FINAL ISSUE
F. P. No. 9321-01-3072
REV. R30 DATE 4/27/73

Westinghouse Electric Corporation F.P. 3072
TITLE: CONSOLIDATED EDISON CO.
INDIAN POINT STATION - UNIT № 2

ELEMENTARY WIRING DIAG.			MOTOR OPERATED VALVE
SKOCZYLAS	7/8/67	7/10/67	499B444
R. WILSON	7/8/67		SHEET - 132
G. Swyers	7/10/67	7/10/67

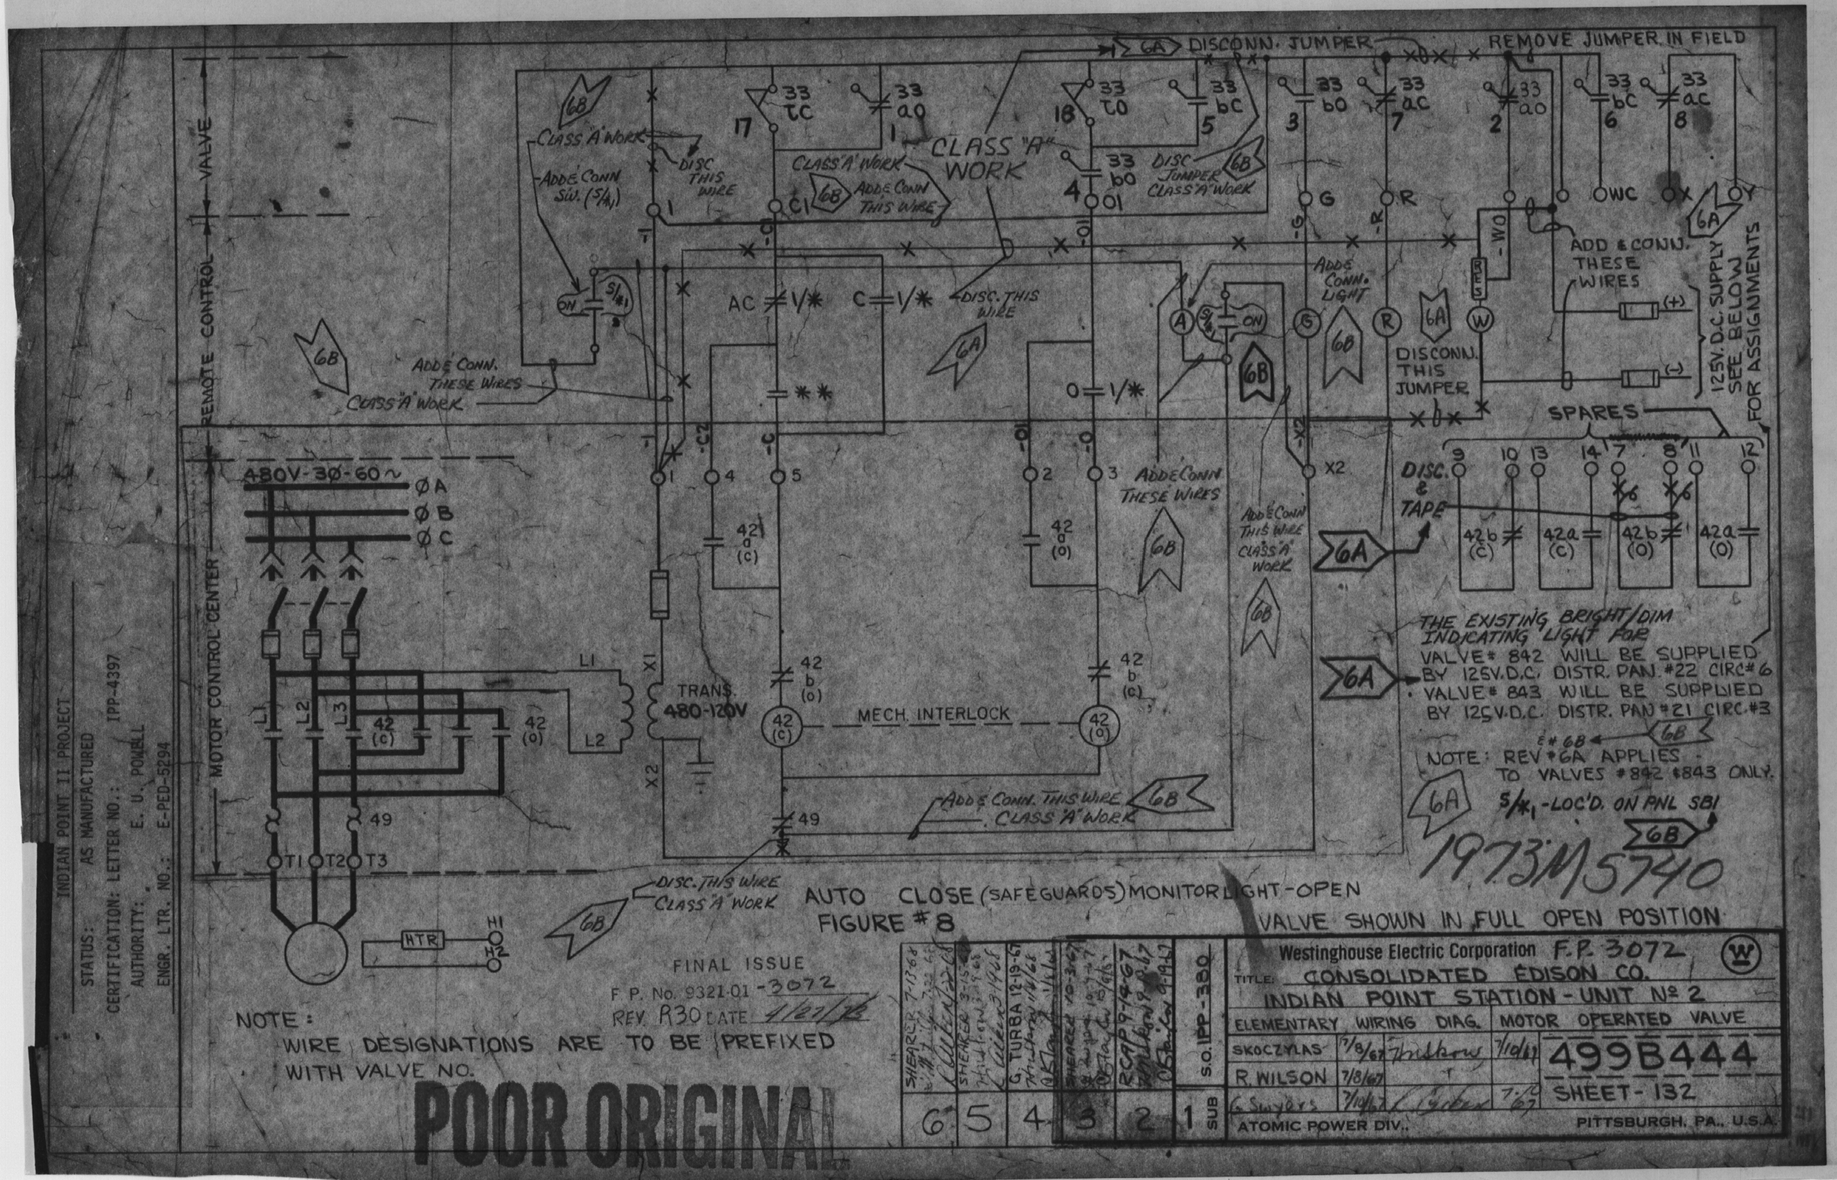
CON. ED. REVISION
LAKBL 4/9/72 6A
THIS REV. IS CLASS "A" PER CI-240-1. IN CONN WITH MODIF OF ECC SYSTEM VALVE CIRCUITRY (PHASE I), MAKE CHANGES AS SHOWN. RELEASED PER CON. EDISON CO. MODIF. PROC # ESG-76-2-07

THIS REVISION IS NON-CLASS "A" AS PER CI-240-1 IN CONN. WITH MODIF. OF ECC SYSTEM VALVE CIRCUITRY (PHASE I). MAKE CHANGES AS SHOWN.
THIS REV. APPLIES FOR VALVES 842 & 843 ONLY
P/N-6039 RB/BTM

Con Edison clean energy
REVISIONS
6B
THIS REVISION IS CLASS "A" PER CI-240-1 IN CONN. WITH MODIF OF ECC SYSTEM VALVE CIRCUITRY (PHASE 2A) ADD & CONN. CONT. PWR. SW (S/#1) & MAKE CHANGES AS SHOWN. RELEASED PER CON. EDISON CO. MODIF PROC # ESG-76-2-07

THIS REV. IS NON-CLASS "A" PER CI-240-1 IN CONN. WITH MODIF OF ECC SYS. VALVE CIRCUITRY (PHASE 2A) ADD & CONN (AMBER) LIGHT & MAKE CHANGES AS SHOWN.
THIS REV. APPLIES FOR VALVES 842 & 843 ONLY.
P/N-6039 J.H./
